[Docket No. FAA-2013-0023; Directorate Identifier 96-CE-072-AD; Amendment 39-17688; AD 99-01-05 R1]

Airworthiness Directives; Various Aircraft Equipped with Wing Lift Struts

ACTION: Final rule.

SUMMARY: We are revising Airworthiness Directive (AD) 99-01-05 for certain aircraft equipped with wing lift struts. AD 99-01-05 required repetitively inspecting the wing lift struts for corrosion; repetitively inspecting the wing lift strut forks for cracks; replacing any corroded wing lift strut; replacing any cracked wing lift strut fork; and repetitively replacing the wing lift strut forks at a specified time for certain airplanes. AD 99-01-05 also required incorporating a "NO STEP" placard on the wing lift strut. Since we issued AD

Figure 1

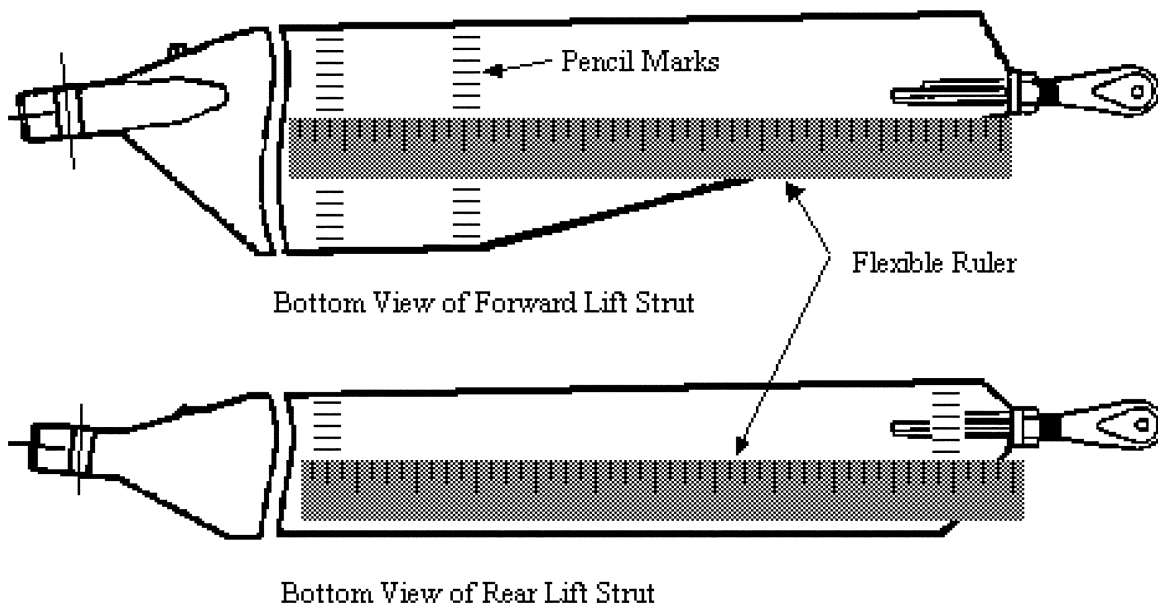
2. Using a flexible ruler, draw a 1/4-inch grid on the surface of the first 11 inches from the lower end of the strut as shown in Piper MSB No. 528D, dated October 19, 1990, or Piper MSB No. 910A, dated October 10, 1989, as applicable. This can be done using a soft (#2) pencil and should be done on both faces of the strut. As an alternative to drawing a complete grid, make two rows of marks spaced every 1/4-inch across the width of the strut. One row of marks should be about 11 inches from the lower end of the strut, and the second row should be several inches away where the strut starts to narrow. Lay the flexible ruler between respective tick marks of the two rows and use tape or a rubber band to keep the ruler in place. See Figure 1.
